Bike to the Future
c/o 3rd Floor – 303 Portage Ave.
Winnipeg, MB
R3B 2B4
www.biketothefuture.org

Bike to the Future Position on the Disraeli Bridge Rehabilitation Project

Location of potential Pedestrian/Bicycle Bridge Linking Bike Routes

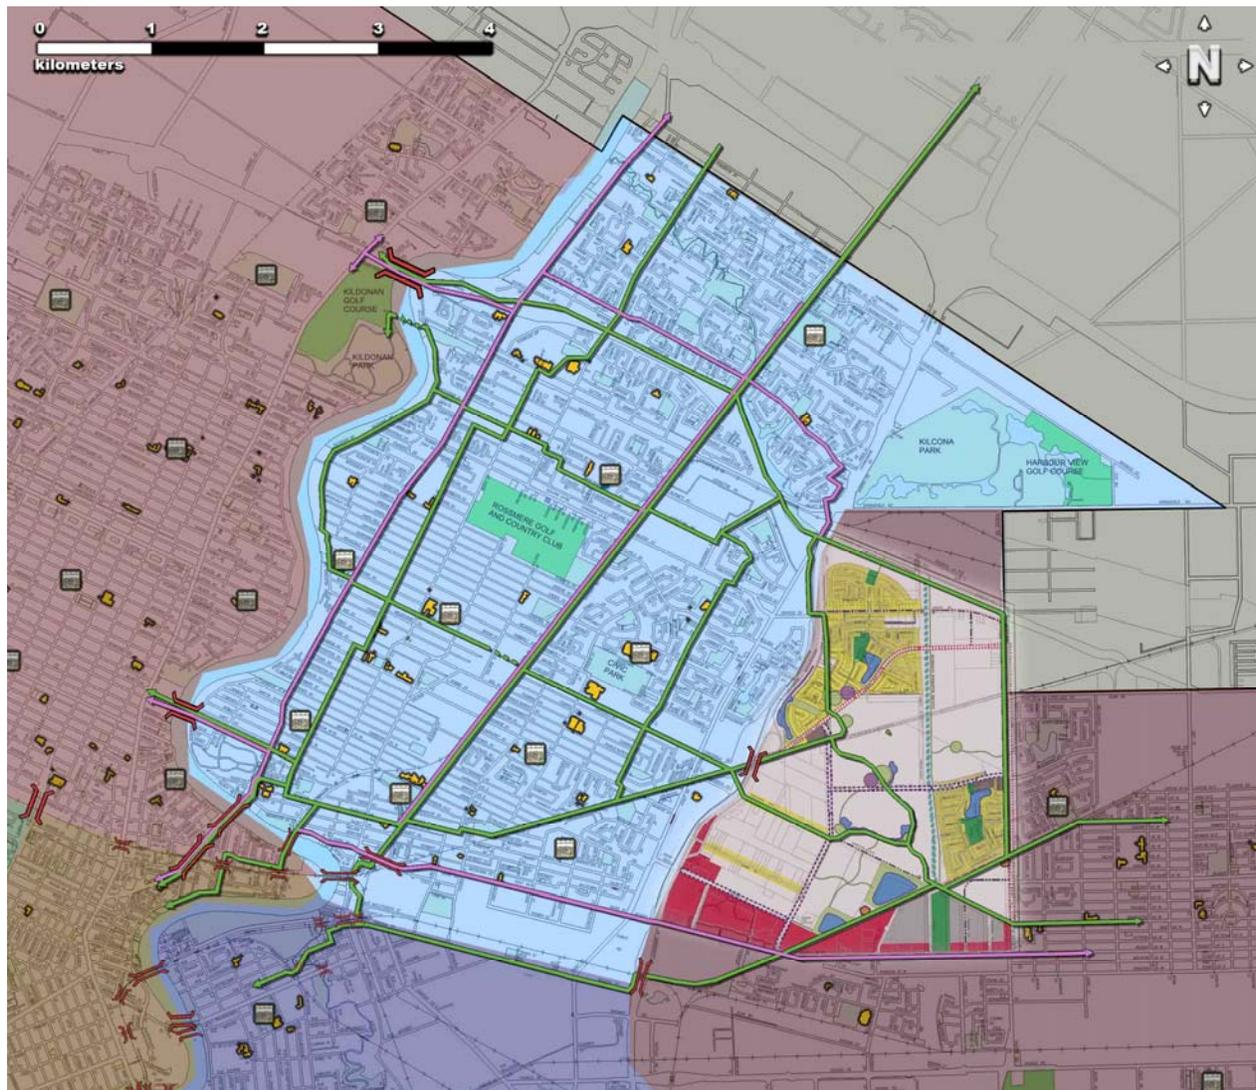
We believe pedestrians and cyclists would be best served by a separate pedestrian/bicycle bridge linking Midwinter to Annabella (possibly via Rover). Such a bridge would link bike routes along Riverton (connecting from the North East Pioneers Greenway) and Brazier (as a bike boulevard parallel to Henderson Highway) to the bike lanes on Annabella leading to Waterfront Drive and the Forks (see map on next page). With this bridge in place, a sidewalk on the Northwest side of the span could serve pedestrians on this side of Henderson while the pedestrian/bicycle bridge serves pedestrians on the Southeast. The cost of the project could be offset by a reduction in costs of the Disraeli Rehabilitation project that we feel would otherwise require widening the piers as in Concepts B and C.
